4745 40th Ave SW

Second Early Design Guidance
DPD# 3014877

Second Early Design Guidance

The Design Review Board first reviewed this project on May 23, 2013. In response to concerns of the Board, a second Early Design Guidance Meeting was requested.

Exhibit E for 23.54.030: Sight Triangle

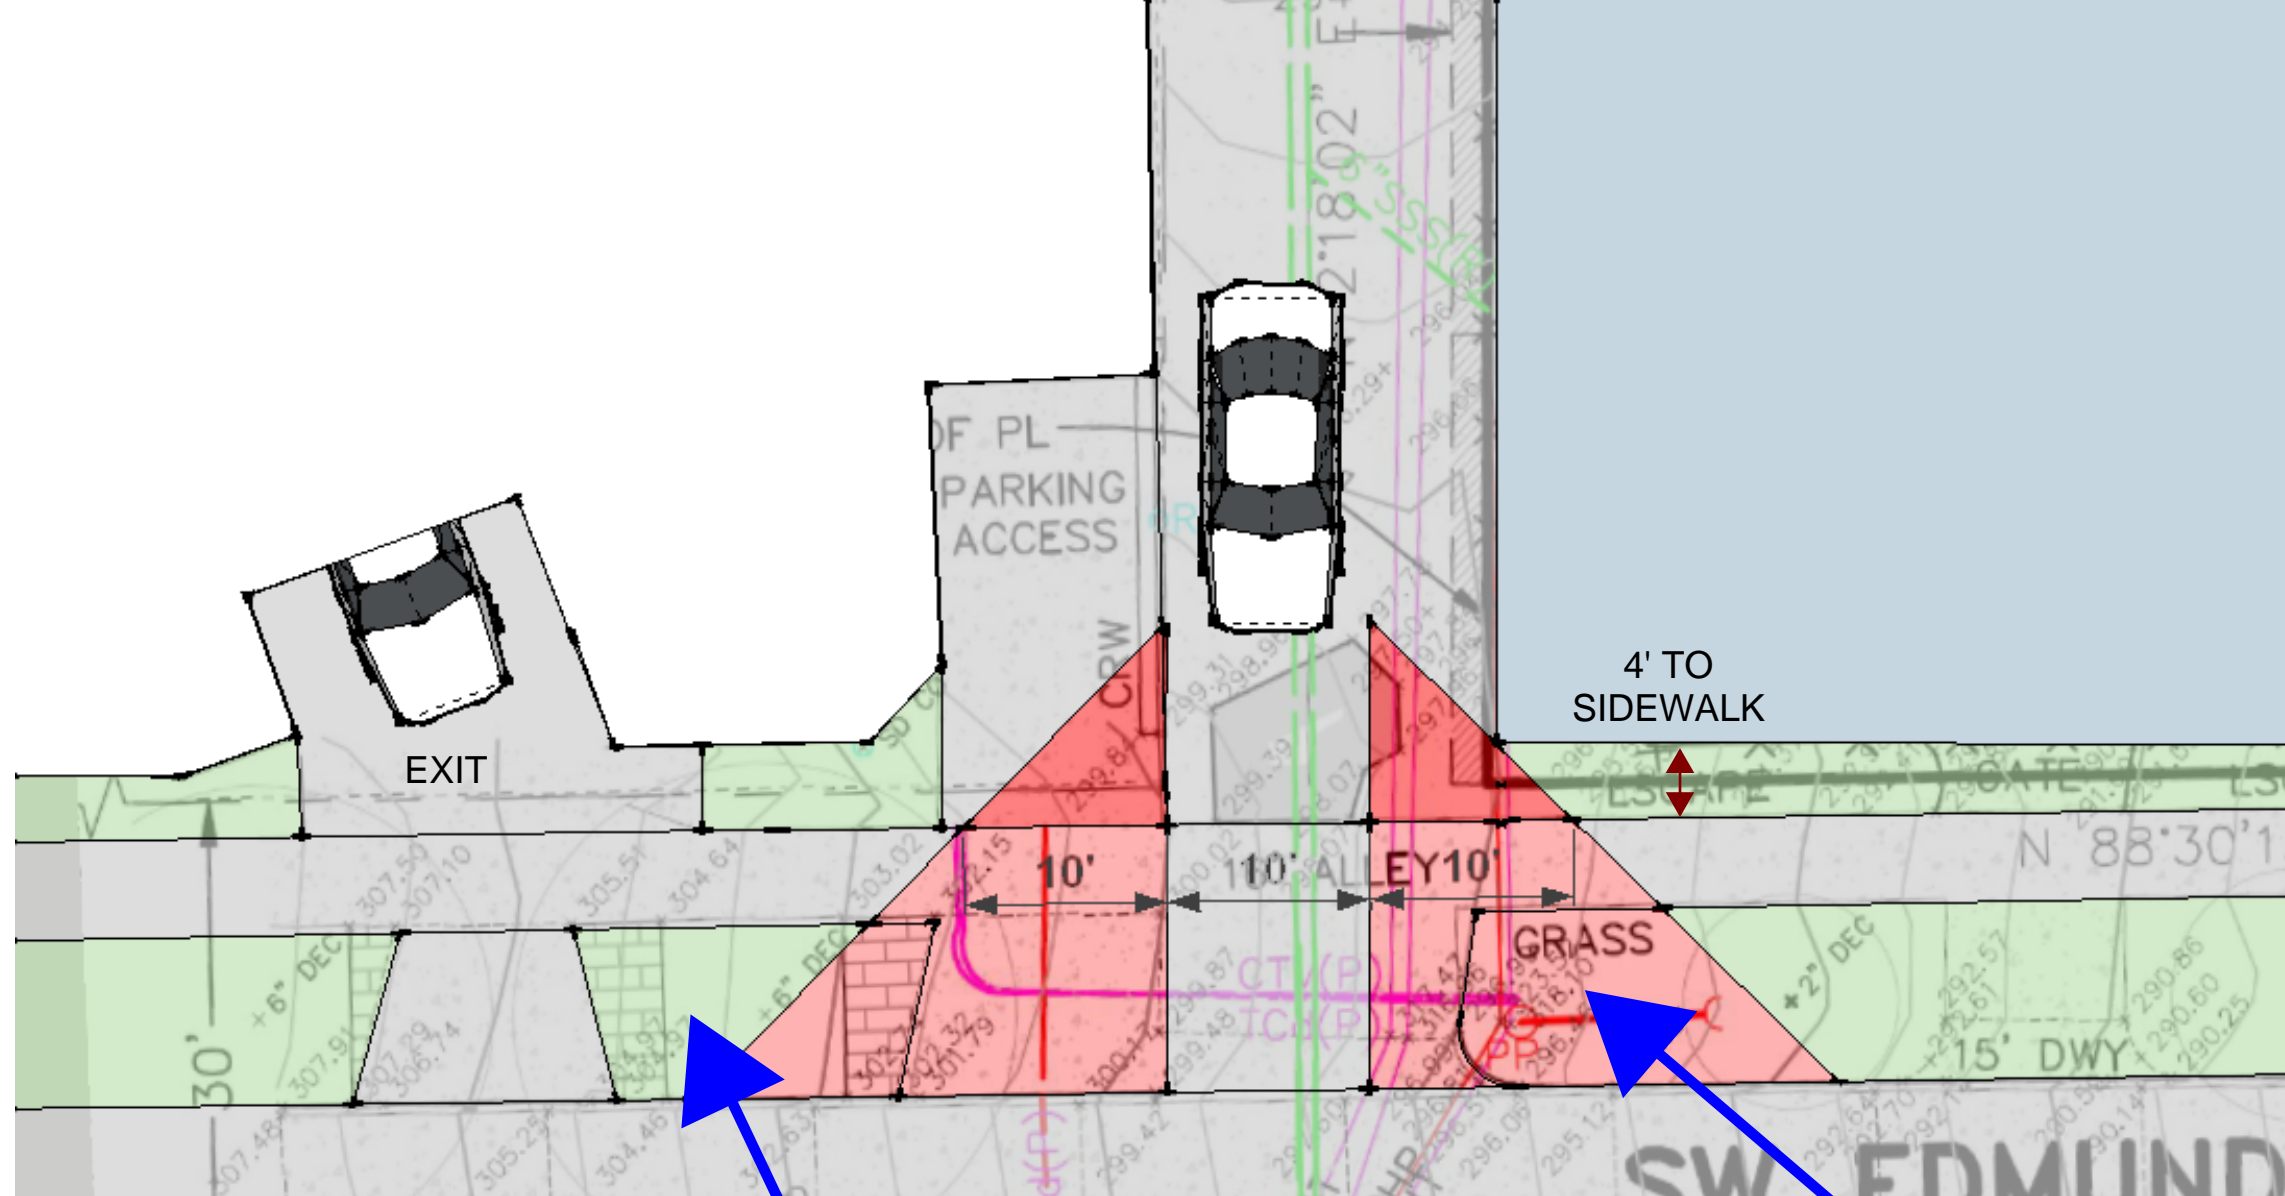
Step the structure back from the alley at the intersection with the Edmunds St. right of way to ensure safe vehicular and pedestrian conditions along the street frontage.

The building is setback at the corner of the alley and right of way intersection to enhance pedestrian safety. The width of the planter strip provides good sight lines to traffic along Edmunds.
